AGENDA
BUILDING & STANDARDS COMMISSION
Monday, July 6, 2026, 6:30 PM

Conduct a Public Hearing and consider a request to amend the Allen Land Development Code by amending in its entirety Article III, "Building Regulations" by adopting the International Building Code, 2024 Edition, with amendments; International Existing Building Code, 2024 Edition, with amendments; International Fire Code, 2024 Edition, with amendments; International Residential Code, 2024 Edition, with amendments; International Mechanical Code, 2024 Edition, with amendments; International Plumbing Code, 2024 Edition, with amendments; International Fuel Gas Code, 2024 Edition, with amendments; National Electrical Code, 2023 Edition, with amendments; International Swimming Pool And Spa Code 2024 Edition, with amendments; and International Energy Conservation Code, 2024 Edition, with amendments.

ORDINANCE NO. _____

23. Section R602.6.1 is amended to read as follows:

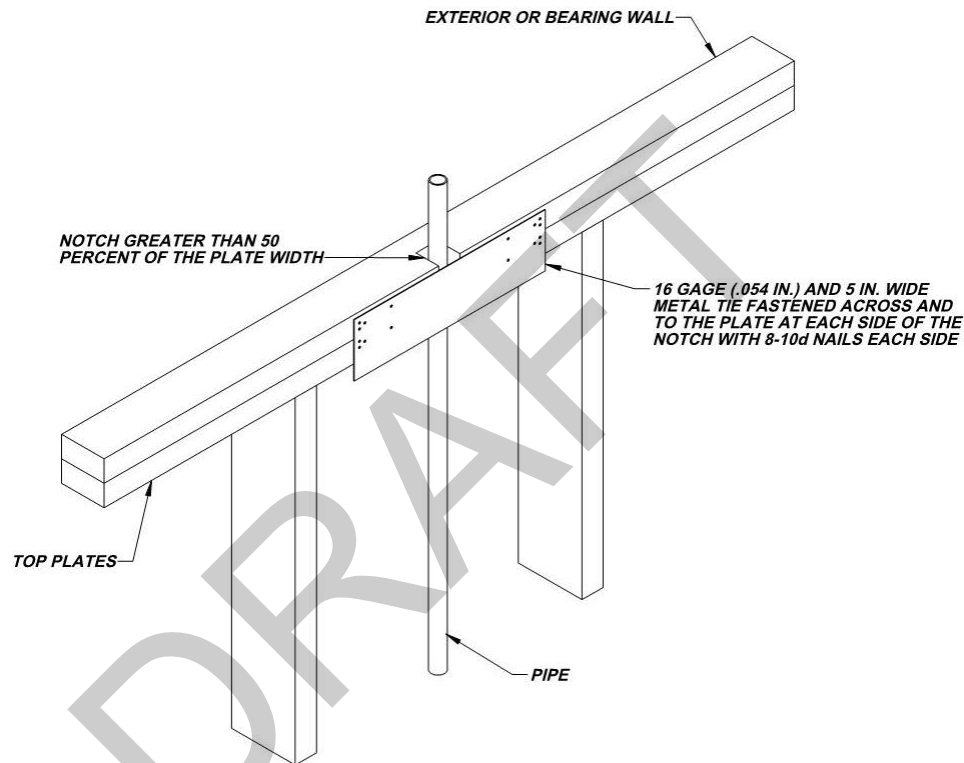
R602.6.1 Drilling and notching of top plate. When piping or ductwork is placed in or partly in an exterior wall or interior load-bearing wall, necessitating cutting, drilling or notching of the top plate by more than 50 percent of its width, a galvanized metal tie not less than 0.054 inch thick (1.37 mm) (16 Ga) and 1 ½ inches (38 mm) 5 inches (127 mm) wide shall be fastened across and to the plate at each side of the opening with not less than eight 10d (0.148 inch diameter) having a minimum length of 1 ½ inches (38 mm) at each side or equivalent. Fasteners will be offset to prevent splitting of the top plate material. The metal tie must extend a minimum of 6 inches past the opening. See figure R602.6.1. {Remainder unchanged}
